Comments on the Environmental Assessment Worksheet and Responses to Comments

Re: Brooklyn Center Opportunity Site #1 Environmental Assessment Worksheet

RE: City of Brooklyn Center - Environmental Assessment Worksheet (EAW) – Brooklyn Center Opportunity Site #1

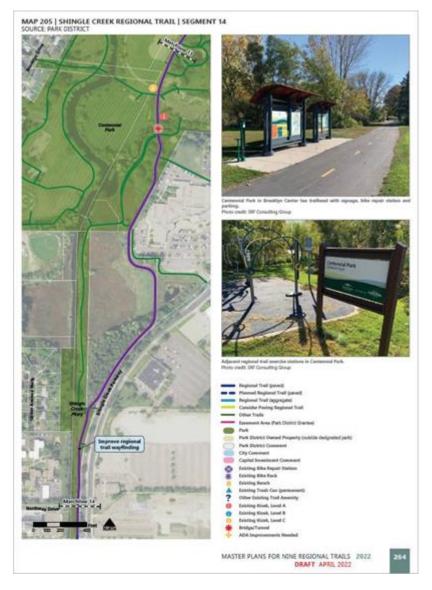
These regional trails are depicted in the EAW (e.g., Appendix A, Site Plan figure), and the proposed project appears to include plans for making connections to them, most directly to the Shingle Creek Regional Trail.

Section 10. Land Use states, "The Shingle Creek Regional Trail is planned to be re-routed through along the northern edge of the proposed project Site."

Council staff is currently reviewing Three Rivers Park District's Shingle Creek Regional Trail Master Plan. Segment 14 of the existing regional trail corridor encompasses most of the project site and is depicted on Map 205 (figure below). The master plan does not depict the Shingle Creek Regional Trail being re-routed through the northern edge of the proposed project site. Instead, the regional trail continues north.

Council staff encourages the proposer (Alatus, LLC) and RGU (City of Brooklyn Center) to coordinate with Three Rivers Park District on implementing local trail connections to the Shingle Creek and/or Twin Lakes Regional Trails in and around the project area.

Response: Comment noted. Final connections to these trails have not been decided. The proposer and the RGU will coordinate with the Three Rivers Park District to implement the local trail connections.
